Access Compliance Report

Public Rights-of-Way

(Curb Ramps)

Intersection ID: 10023717	Main Street: COLEY_VIEW_CT	Cross Street: N/A	Location: NE
ADA ID: DB9E9A96AED5	Ramp Type: Perp	Initial Pass/Fail: Fail	Overall Compliance: No
Codes/Mitigation Info/Possible Solution		Field Measurements/Component Compliance	
Severity Score: 26.25

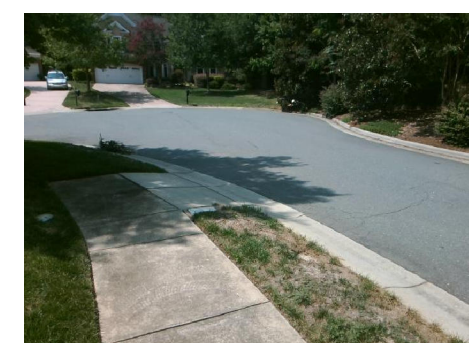
Possible Solutions:	Compliance	Description	Data	Compliance	Description	Data
	Remove & Replace Entire Ramp.	N/A	Ramp Length (in)	42.0	No	Ramp Slope (%)	14.8
		Yes	Ramp Width (in)	97.0	Yes	Ramp XSlope (%)	2.9
		N/A	Flare Type LT	N/A	N/A	Flare Type RT	N/A
		N/A	Flare Slope LT (%)	N/A	N/A	Flare Slope RT (%)	N/A
		N/A	Flare Traversable LT?	N/A	N/A	Flare Traversable RT?	N/A
		N/A	Landing Length (in)	N/A	N/A	DWS Provided?	N/A
		N/A	Landing Width (in)	N/A	N/A	DWS Contrast?	N/A
		N/A	Landing Slope (%)	N/A	N/A	DWS Length (in)	N/A
		N/A	Landing X Slope (%)	N/A	N/A	DWS Full Width?	N/A
		N/A	Landing Curb? (Y/N)	N/A	N/A	DWS Offset (in)	N/A
		N/A	Shared Landing?	N/A			
		N/A	Gutter Ponding?	N/A	N/A	Gutter Slope (%)	N/A
		N/A	Gutter Lip Ht (in)	N/A	N/A	Gutter X Slope (%)	N/A
		N/A	Painted X Walk1?	No	N/A	Painted X Walk2?	N/A
Surveyor Notes: N/A PROW/ADA: Not Found, R304.2.2			X Walk 1 Direction	To W		X Walk 2 Direction	N/A
